Re: oLiv Sound Isolation Study Phase 2 (Revision)
Madison, WI
KN° 3243

PROJECT UNDERSTANDING

Kirkegaard was engaged by Antunovich Associates to provide an acoustic study of the predicted sound isolation at a ten-story student housing project in Madison. Our study will focus on airborne sound isolation between bars on the first floor occupying a 15,000 sf space and residential units directly above on the second floor. We understand that Core Spaces is working on the lease and work letter and wants to understand the isolation with the current design and what details would be required for greater isolation. The potential Tenant's schematic design shows four different bar types, and each may involve different expected noise levels; the "Roxxy 2" bar has a stage and dance floor and is connected to the "Roxxy 1" bar, "Double Tap" is more arcade oriented, and the other bar is "Olive".

“Better” Recommended Ceiling

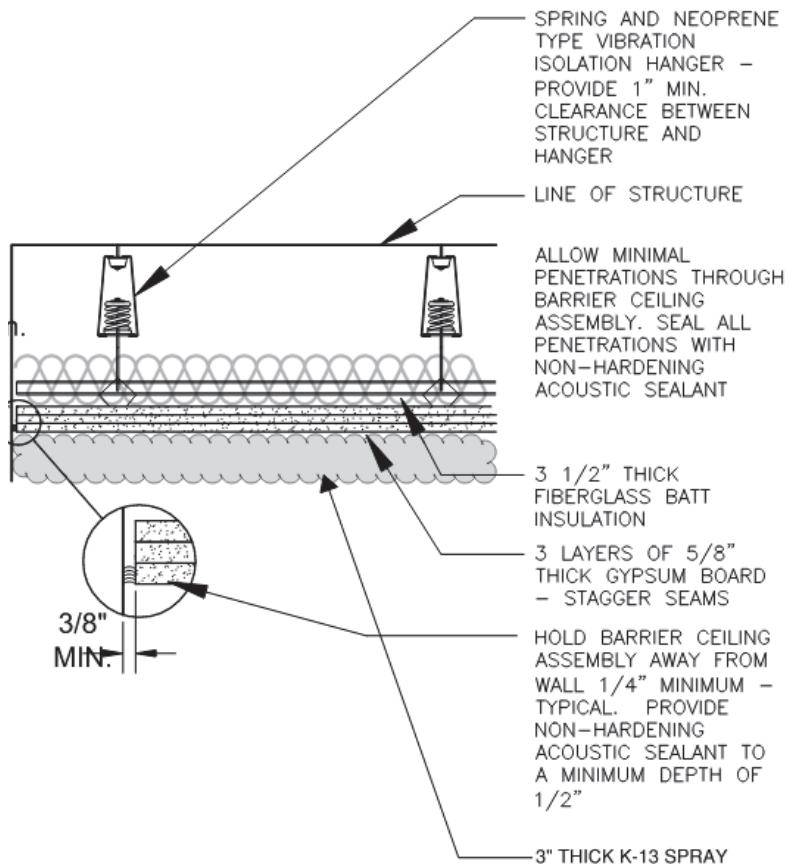
- Gypsum Board Barrier Ceiling

- Gypsum Board Barrier Ceiling
- 3 layers 5/8" gypsum board, hung from bottom of structure with spring and neoprene isolators.
- 3" thick batt insulation resting above gypsum board.
- Seal perimeter airtight with acoustic sealant.
- Minimum 14" airspace between barrier ceiling and bottom of structure.
- MEP serving the first floor should all be located and routed below the barrier ceiling to avoid penetrations through the gypsum board.
- Treat underside of gypsum board with minimum 80% of ceiling area of 3" thick K-13 spray for loudness control within room.

“Best” Recommended Ceiling

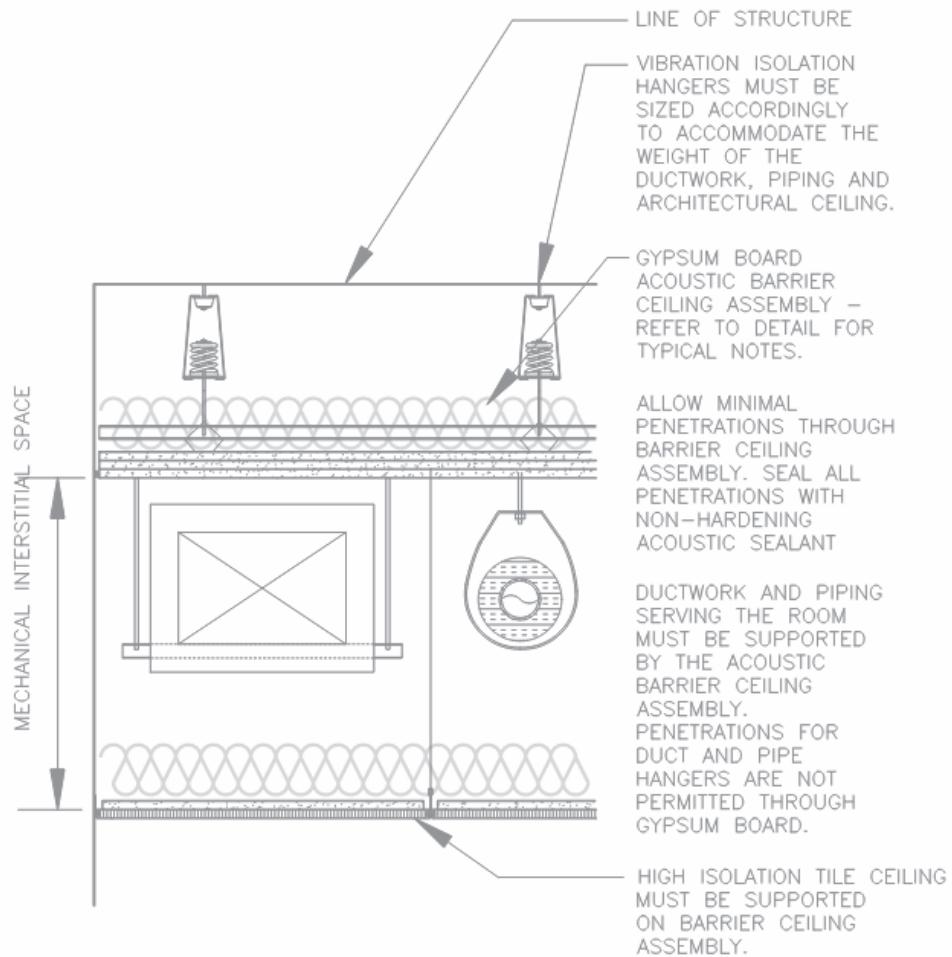
- High Isolation Acoustic Ceiling Tile + Gypsum Board Barrier Ceiling

- High Isolation Acoustic Ceiling Tile + Gypsum Board Barrier Ceiling
- ~~Gypsum board barrier ceiling as previously defined, hung minimum 14" below slab.~~
- ~~High isolation acoustic ceiling tile as previously defined, hung minimum 14" below barrier ceiling.~~
- ~~MEP serving the first floor should all be located and routed below the barrier ceiling to avoid penetrations through the gypsum board.~~

KIRKEGAARD RECOMMENDED CEILING TREATMENT EXTENTS

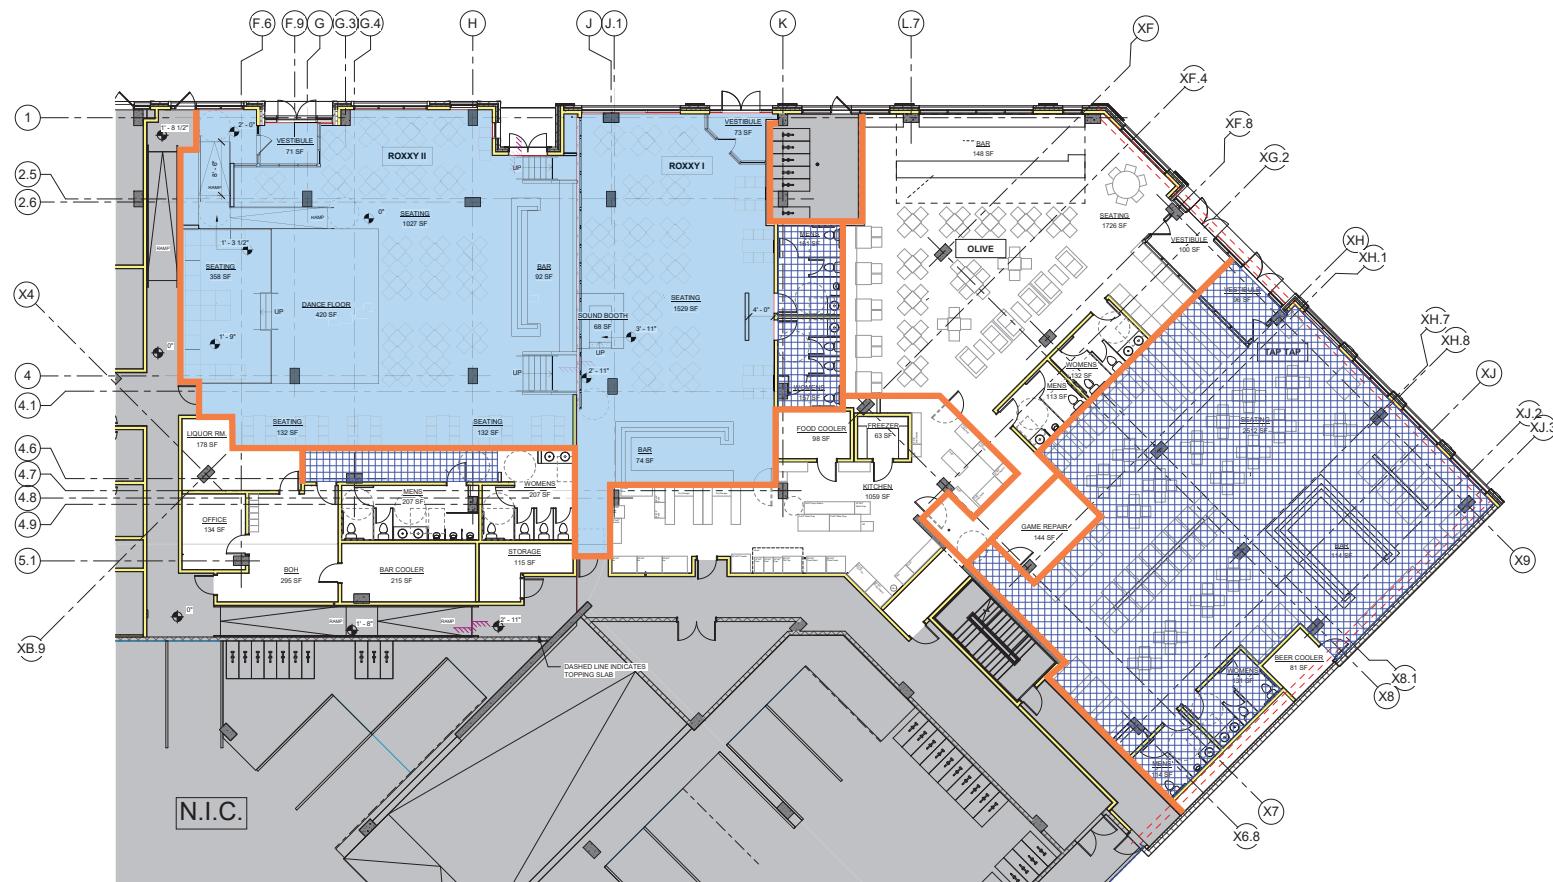
"BETTER" GYP BD BARRIER CEILING

"GOOD" HIGH ISOLATION ACT CEILING

FULL-HEIGHT, INSULATED PARTITIONS CONTINUOUSLY SEALED TO STRUCTURE. DOORS REQUIRE FULL-PERIMETER GASKETING.

We recommend the “Better” treatment should cover the entire ceiling above both Roxxy spaces. After further review from our previous discussions, there is greater overlap above than originally thought (see attached markup). The reason for including the barrier ceiling below the green roof is that it is difficult to predict how sound energy might energize the concrete slab and travel horizontally into 2nd floor units (bypassing the barrier ceiling).

If the entire ceiling area is not possible, the barrier ceiling must exist at minimum in the area 2' beyond the perimeter of the residential unit footprints above Roxxy 1 and Roxxy 2. This area is indicated on the attached ceiling treatment markup. All layers of gypsum board of the barrier ceiling should continuously return to structure above and seal airtight with a soft joint. And at minimum, the rest of Roxxy and restroom corridor should have “good” ceiling type. If left untreated with only exposed slab, the noise traveling horizontally from the portion of exposed slab into 2nd floor units may be audible and somewhat loud at particular frequencies.
